ADDENDUM 3

DATE: November 18, 2016
PROJECT: MSB First Floor Infill LRC 3 & 4
RFP NO: 744-R1705
OWNER: The University of Texas Health Science Center at Houston
TO: Prospective Proposers

This Addendum forms part of and modifies Proposal Documents dated, October 19, 2016, with amendments and additions noted below.

Reflected Ceiling Plans - Level 1

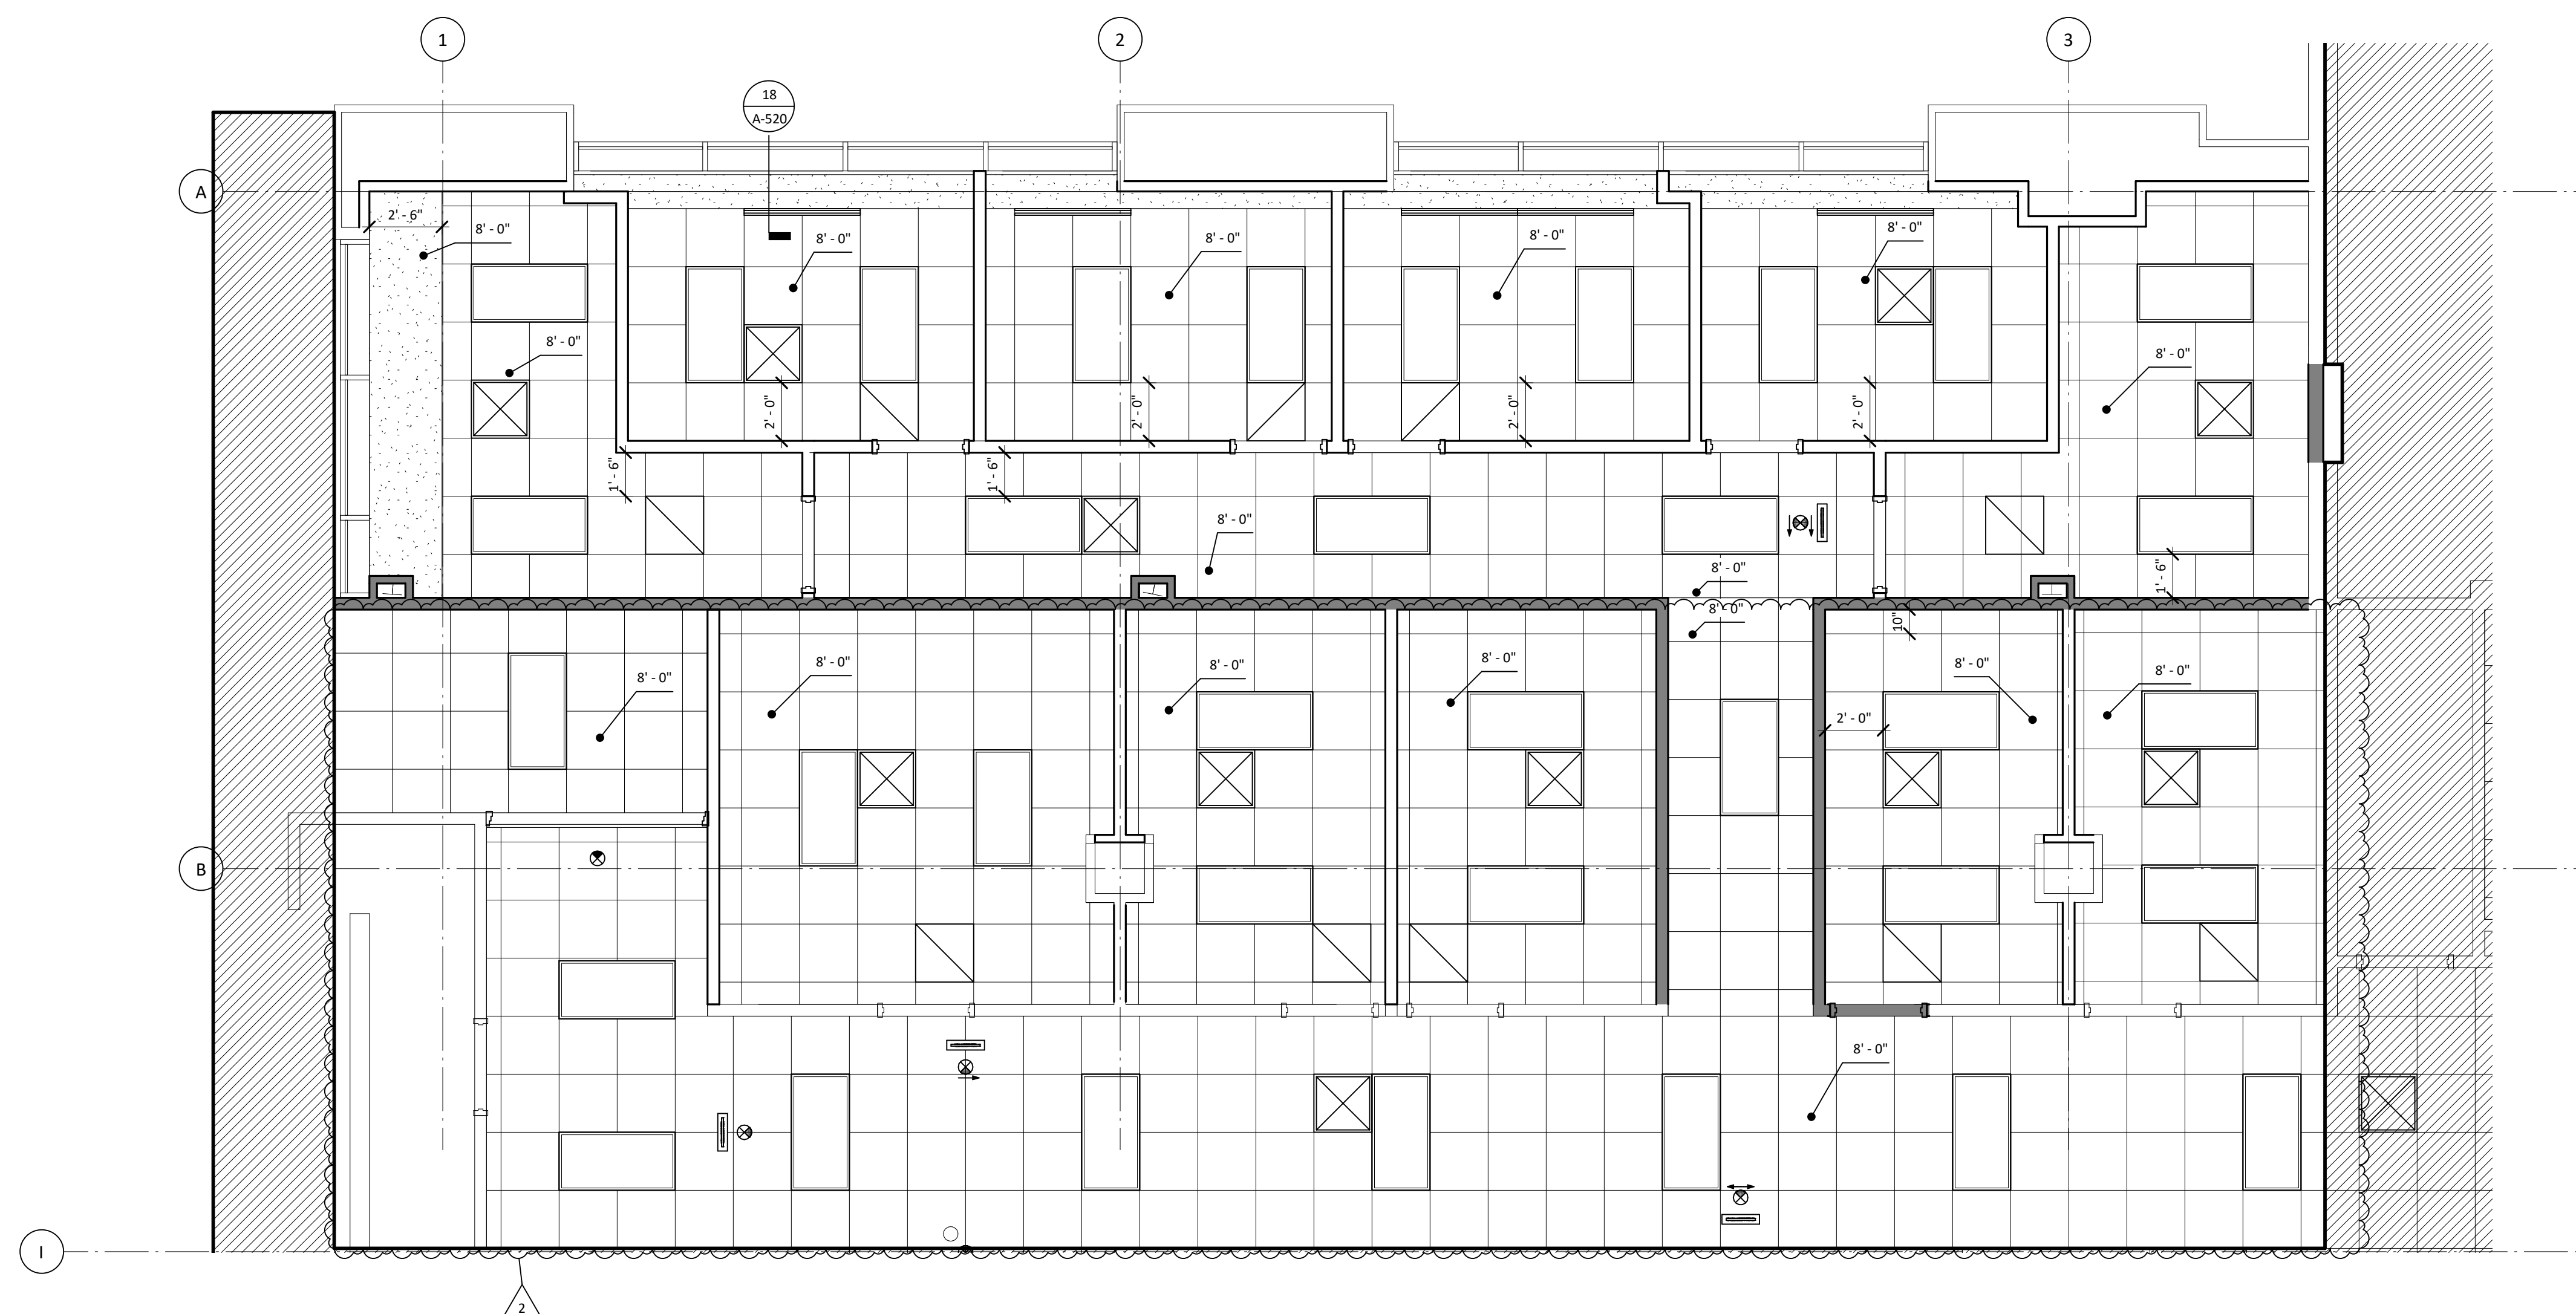
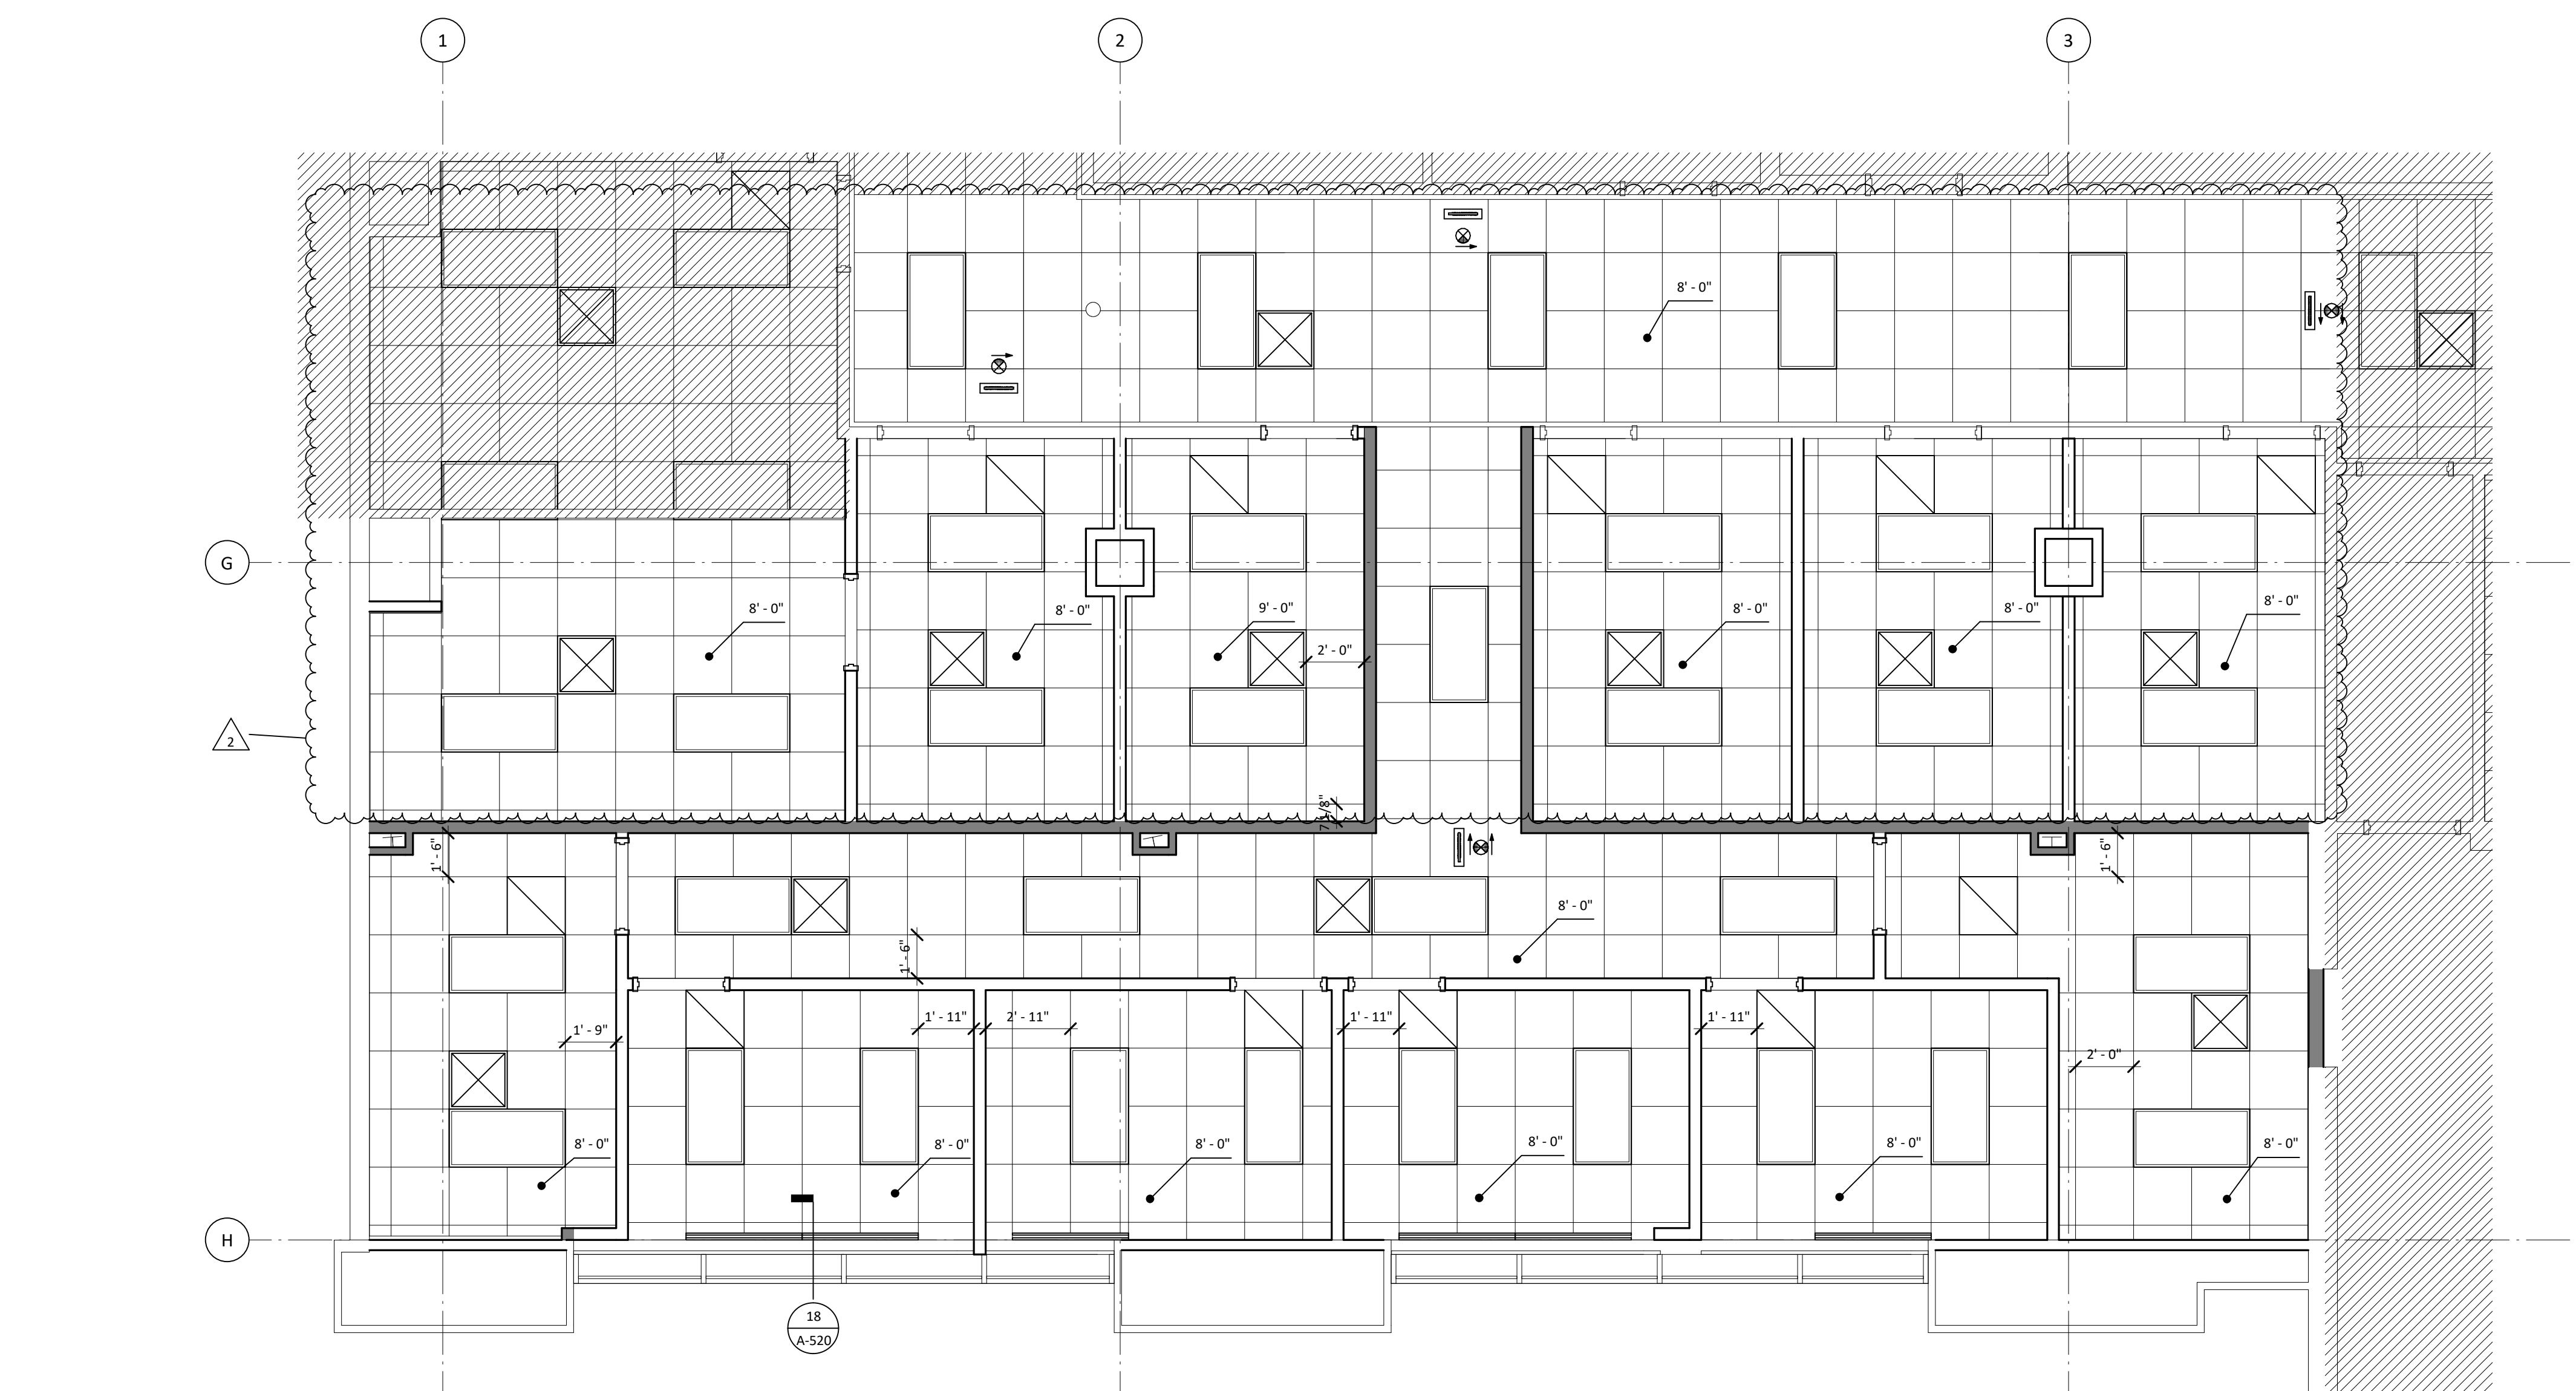
22. On drawing A-161 - Reflected Ceiling Plans Level 1, does not indicate the need for furr downs for the beams that will be installed. Ceiling grid is shown to be installed at 9'. Please confirm that the beams will be below that elevation.

31. On drawing A-160 & A-161 the reflective ceiling plan show 2 x 2 ceiling tile. On drawing A-540 the schedule has ACT 1 and 2. Please confirm where ACT 1 and 2 are needed on the drawing.
Only ACT 2 (2'x2') is in the project

- All new ceilings to be 9'-0" a.f.f., unless noted otherwise. See Finish Schedule for types.
- Center all sprinkler heads and ceiling mounted devices in center of ceiling tile, unless noted otherwise.
